Product Change Notification

October, 2015

Bourns® Model SRN1060 Semi-shielded Power Inductor Series ***Change to the Packaging Specification, Minimum Order Quantity*** ***and Multiple Ordering Quantities***

Packaging Specification of the Tape & Reel Carrier Change:

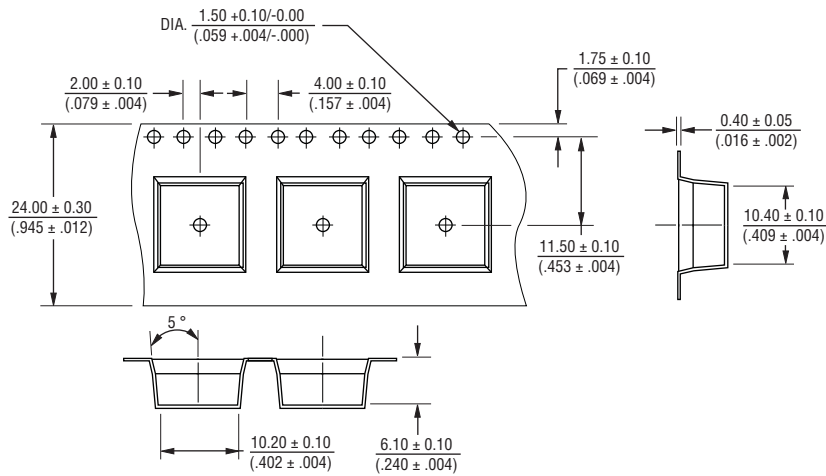
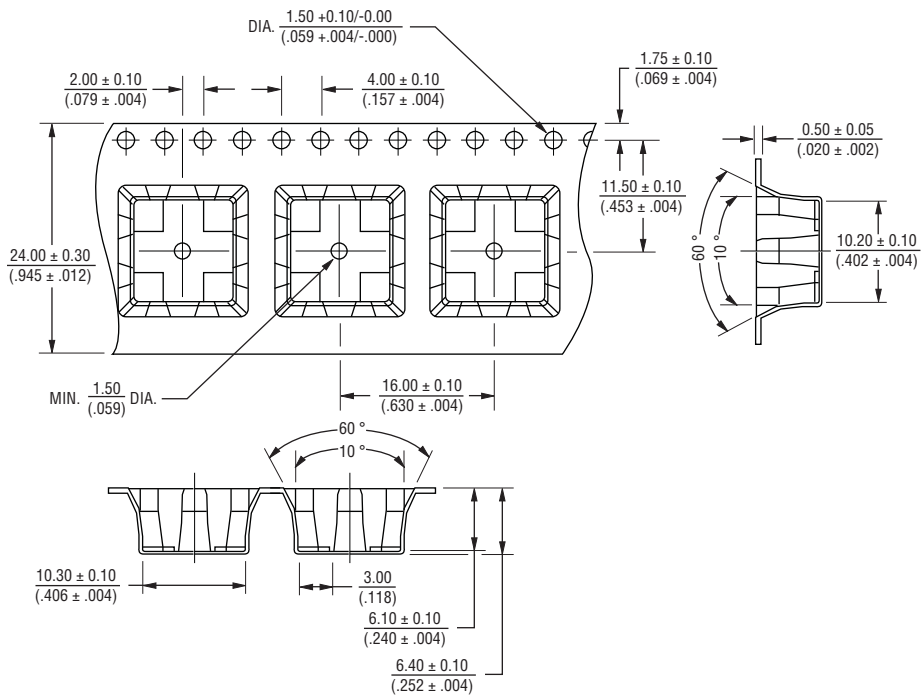
The packaging specification of the tape and reel carrier for the Bourns® [Model SRN1060](#) Semi-shielded Power Inductor Series has been redesigned to include embossment on four sides and the bottom of the carrier tape. The new embossed design provides better shock absorption than the previous design without embossment. The embossment helps protect the inductor during shipping and handling. Figures 1 and 2 highlight these changes on the following page.

As the result of the tape carrier redesign, the component package per reel quantity is reduced from 650 pieces to 600 pieces. The Minimum Ordering Quantities (MOQ) and the Multiple Ordering Quantities (Mult) of the series have also changed from 650 pieces to 600 pieces.
